Attention: Leah Cameron, Agent
Subject: Submission of revised septic design plans
Reference: Lee Robinson, lots 3 and 4, Upton Street

Please find enclosed one copy of our revised septic design plans for lots 3 and 4. The changes made are as follows:

On-Site Sewage Disposal System

Located At
Lot 4
183 Upton Street
Assessors Parcel 86-0-11
Grafton, MA
Owned By
Roger Lee Robinson

SYSTEM PLAN

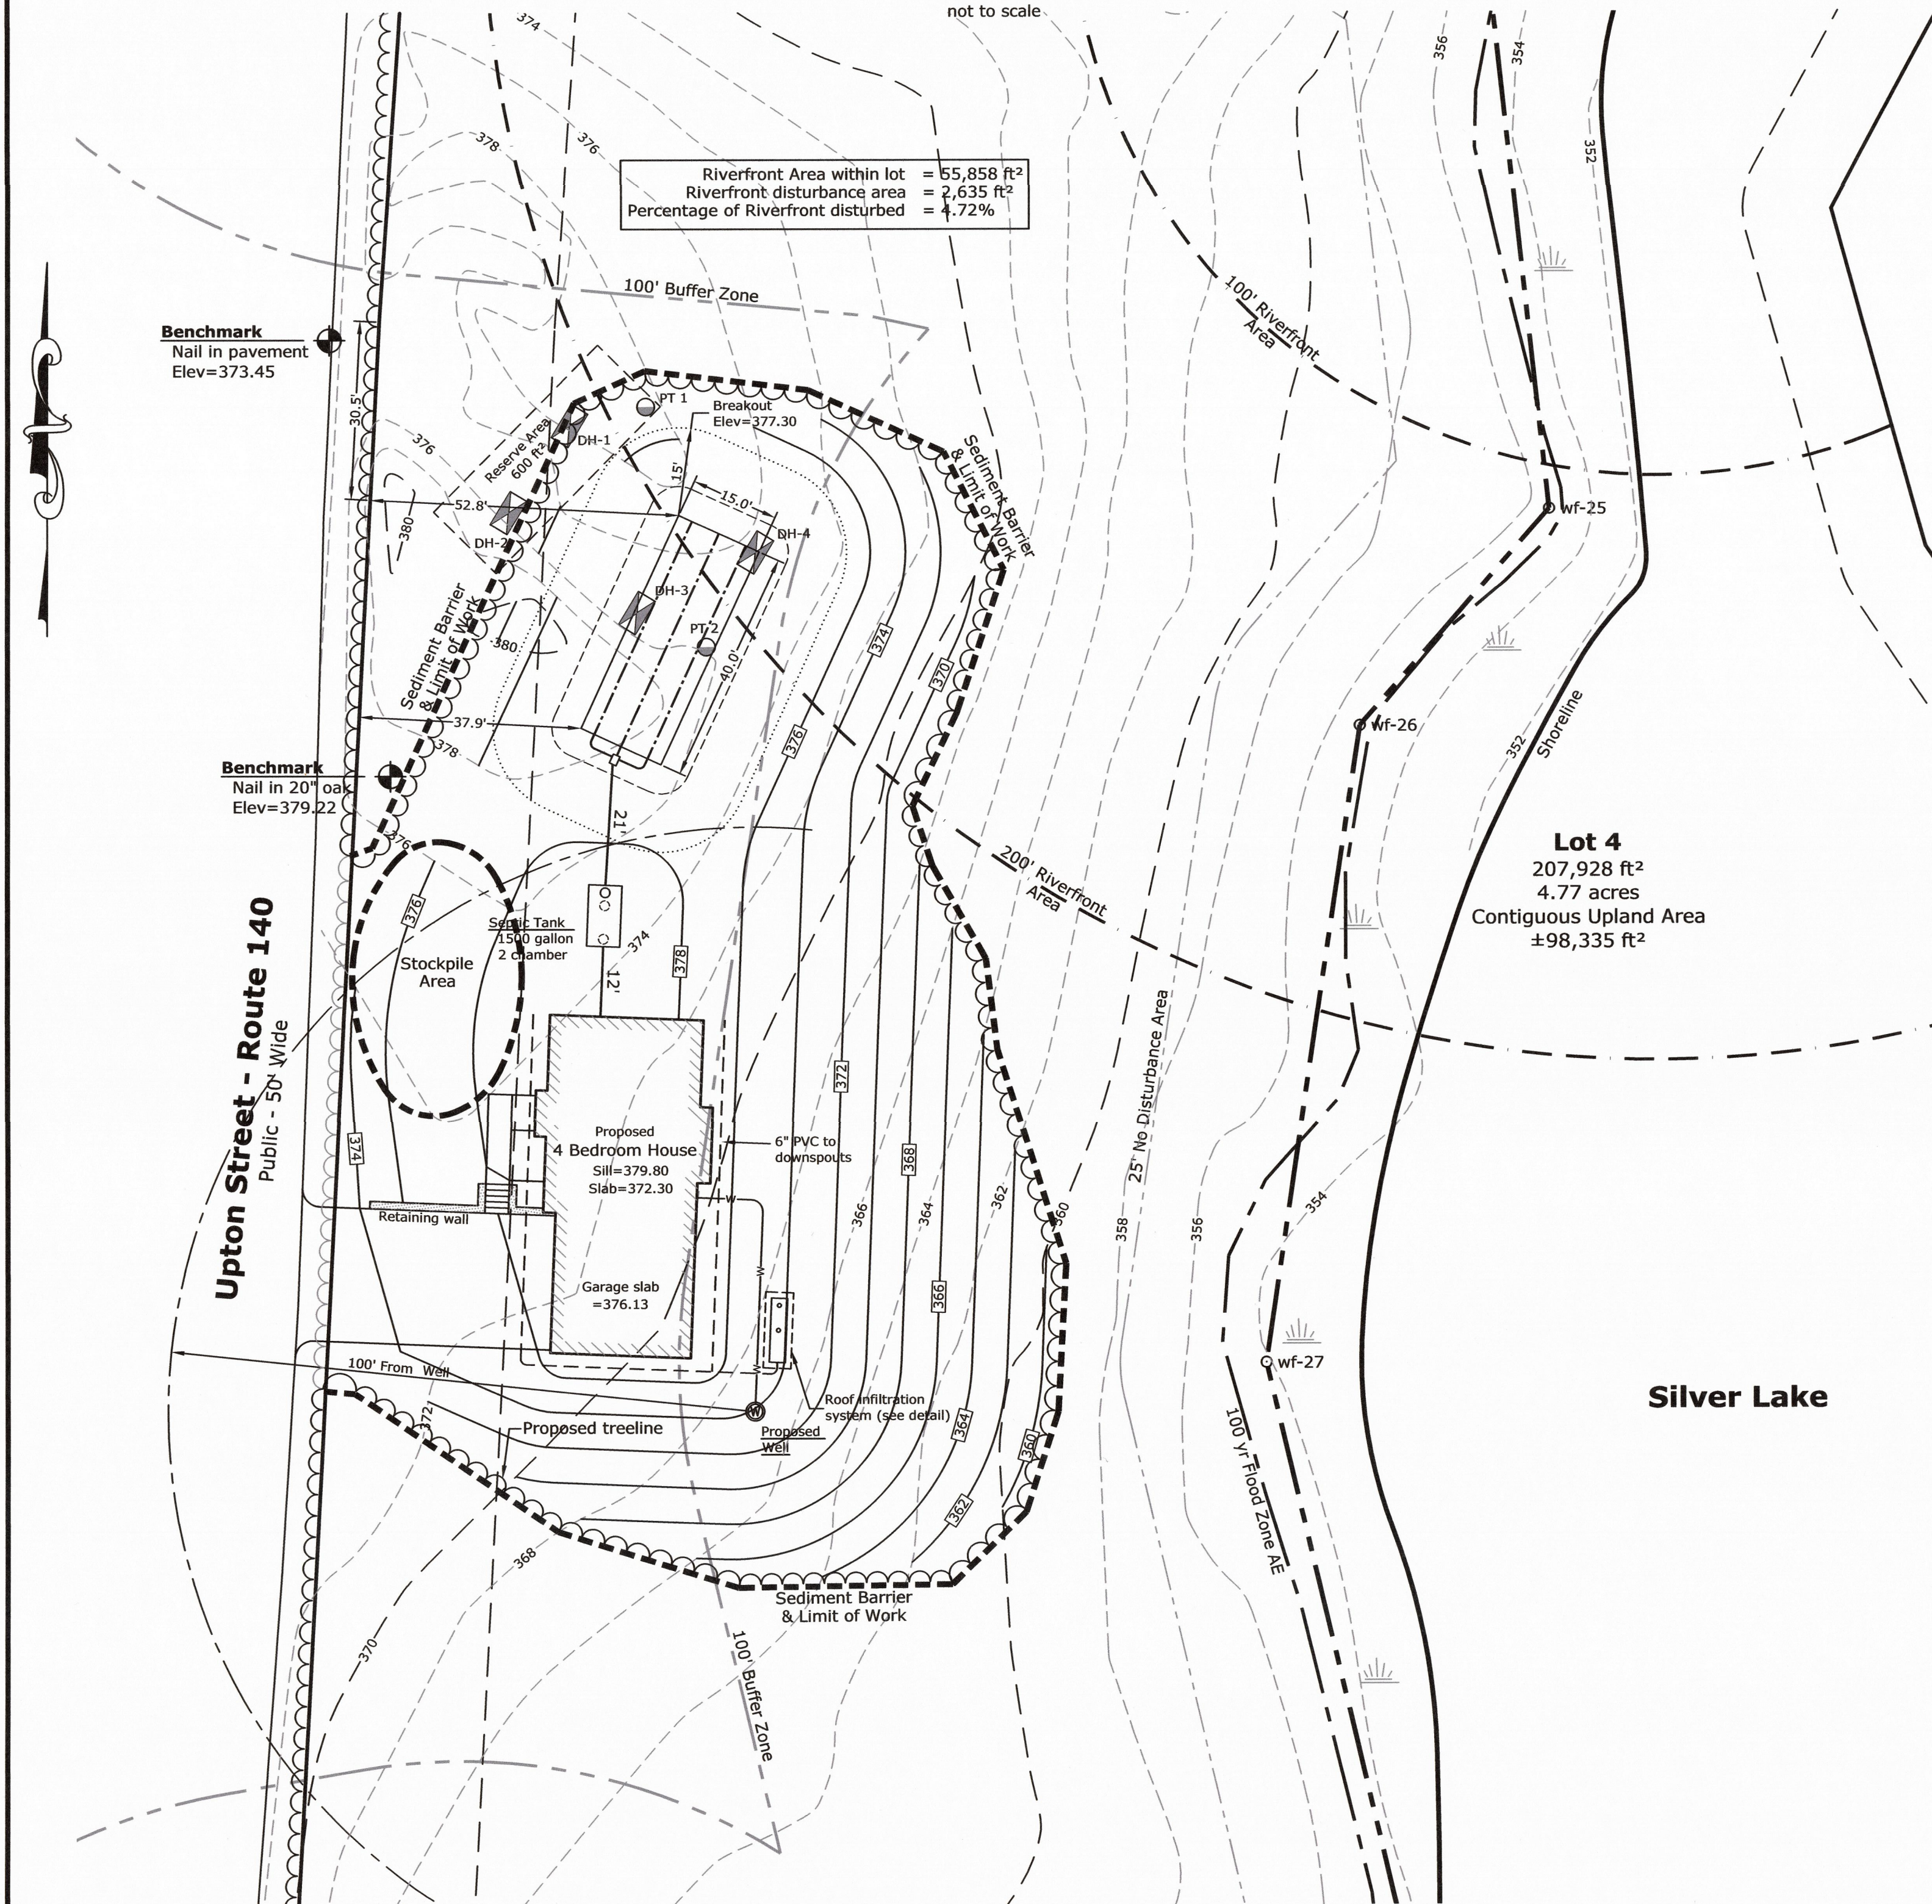
- On lots 3 and 4, we moved the stockpile area out of the buffer zone, and we added the upland area for both lots.
- On Lot 3 we moved the proposed siltation controls out of the 25 foot no disturb zone.
